DATE: APRIL 2, 2014

FROM: HISTORIC PRESERVATION STAFF

SUBJECT: 711 PRINCE STREET,
BAR CASE # 2014-0018 & 2014-0019

ISSUE: Partial Demolition/Capsulation and Addition

Figure 1. View of the northwest corner of the existing building from South Columbus Street

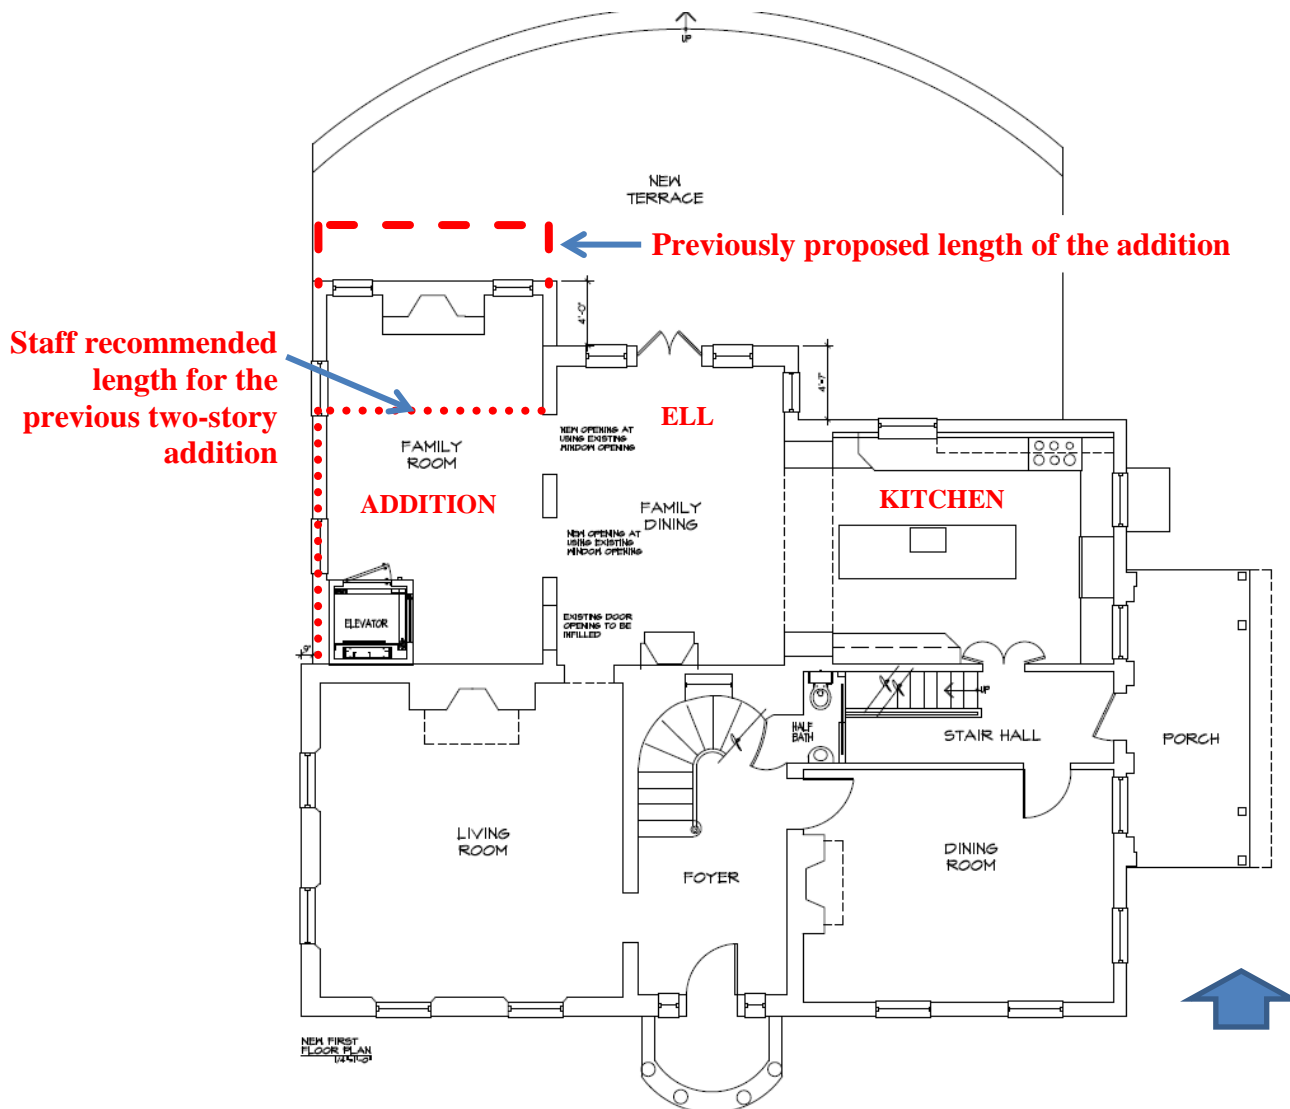
Although reduced from the original proposal, staff still has some reservations about the extent of the footprint of the first floor of the addition. The two story ell shown in the previous report extended 7'-6" north of the historic center ell. In that report, staff suggested a footprint for the addition that was recessed approximately 4'-6" south of the north wall of the center ell, to align with the north wall of the flounder on the other side of the ell, insuring that the mass of the addition was clearly secondary to the historic portions of the house. The revised application is now pulled back to 4'-0" north of the ell. While staff still prefers a smaller addition, the present single story proposal has significantly less adverse effect on the adjacent two story ell and can be supported in the overall scheme. As shown in Figure #1 below, a one story addition will still be visible but will obscure much less of the original building from South Columbus than the previous proposal.

Figure 3. The applicant's revised second floor plan with staff recommendation for a reduced addition to accommodate an elevator with a door on the east side.

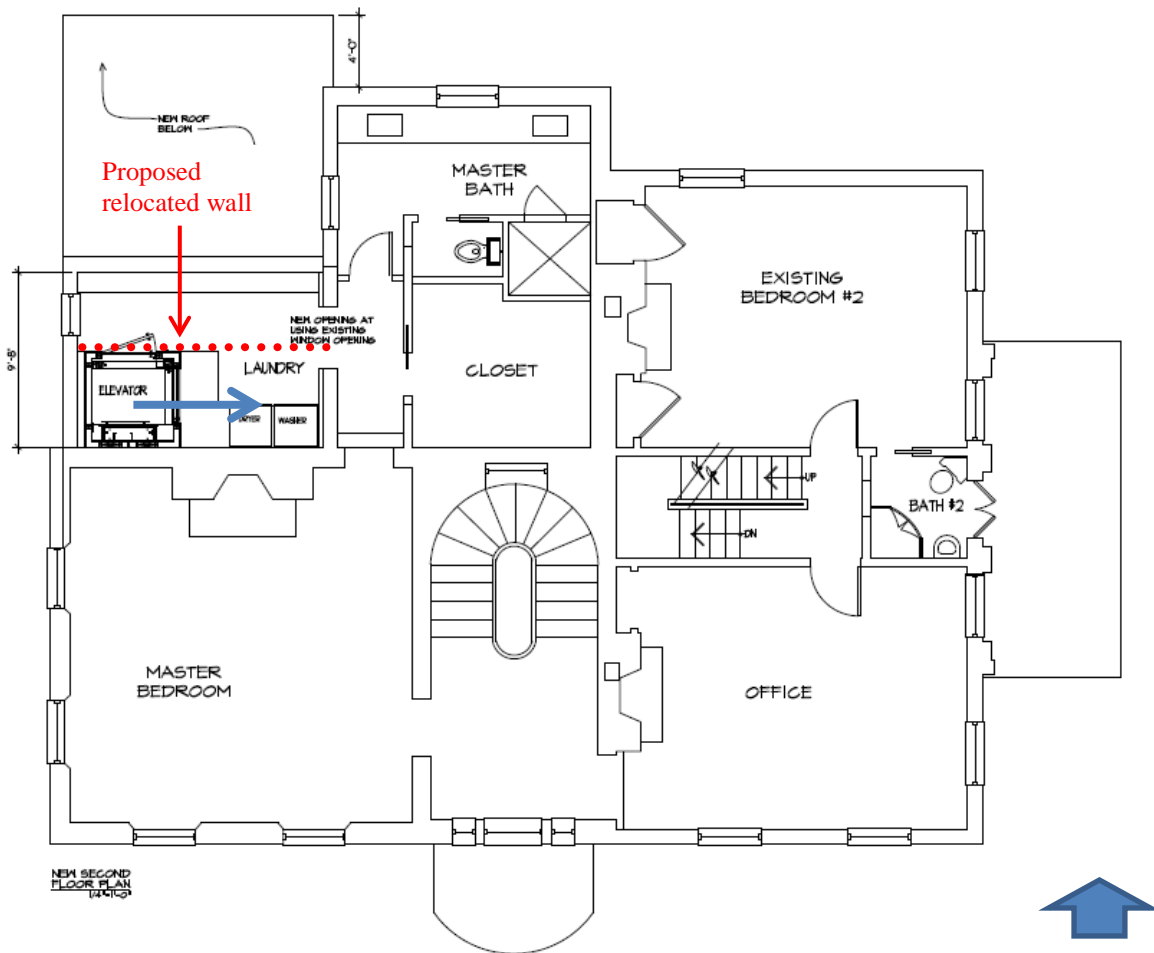
A second option, shown in Figure #3 below, is a simple shed roof addition that might recall a small enclosed sleeping porch, extending approximately six feet from the north wall of the historic building. The elevator cab could have two doors, as it did in the previous submission, so that the cab could exit to the east on the second floor, or the door could be located on the east side of the cab on all floors. This alternative eliminates the small window on the west elevation of the enclosure. It also requires the existing second floor masonry window (shown on the plans as a door) opening in the center ell to shift south a few feet. The door and window openings are irregular on the west façade of the ell and appear to have been altered in the past. This is the alternative suggested by staff, as it significantly reduces the mass of the second floor addition as viewed from Prince Street (see Figure #4 below).

At a minimum, the present elevator enclosure extension could be reduced another foot and lose only what appears to be shelving on the north wall. This version of the enclosure would extend north approximately nine feet overall and would still allow room for a generous laundry. Staff notes that the width of the second floor enclosure shown on the applicant's New West Side Elevation drawing scales approximately 11'-4" while the plan indicates only 10'-4", so another foot narrower than this plan dimension indicates would further improve the proportions.

2. Reduce the footprint of the elevator enclosure at the second floor to extend no more than 6'-6" north of the historic structure.
3. All windows, doors and materials must comply with the Board's adopted policies and be approved by staff, in conjunction with approval of a building permit.

Figure 6. Applicants proposed rear elevation with staff's alternative, one story shed roof addition outline.

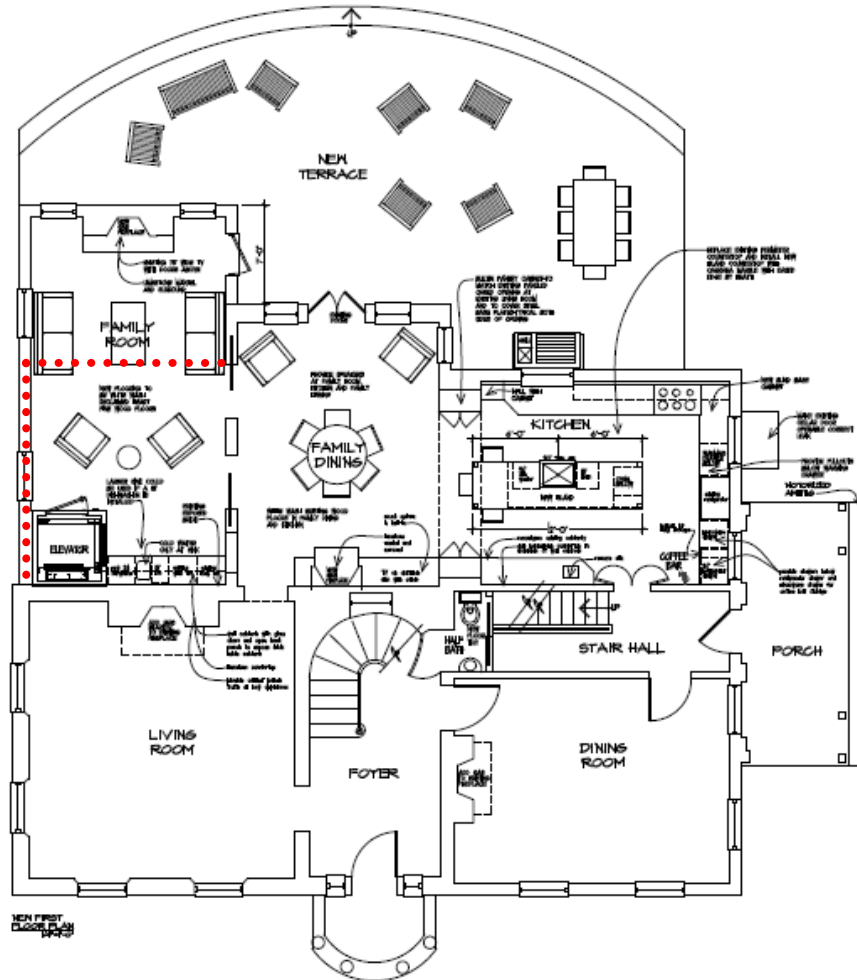
However, staff still believes that the proposed addition is too large for this nationally significant house. While the addition is clearly differentiated and simple in its form and choice of vernacular material, it blocks the view of the existing north elevation and historic ell from Columbus Street and projects significantly further to the north than the existing ell. The proposed north elevation, never formally composed, becomes a visual cacophony of shed and gable forms. The new addition is not, therefore, a successful background element due to its mass and its visual and physical impact on the historic building. Staff feels strongly that no addition would be the best alternative for preserving this very significant property.

However, should the Board agree to the applicant's request for some additional building area, a well-designed and sensitive one-story addition may be acceptable. Staff's first preference would be for a distinctly separate folly or garden conservatory addition extending north of the existing ell, so that it would not touch the main building mass. Alternatively, a much smaller addition to the west of the existing ell, with minimal visual impact above the first story, would be preferable to the present proposal.

A reduced addition should extend no higher than the bottom slope of the roof of the existing rear ell and be set well back from the north wall of the ell. This would significantly reduce the visual impact of an addition from both Prince and South Columbus streets and minimize the physical impact on historic fabric, preserving the view of the unusual triangular wall siding above. Alternative space should be available for the presently proposed second floor function. Staff has suggested an elevation and plan outline of a single story addition with a reduced footprint for the Board's consideration in Figures 5 and 6.
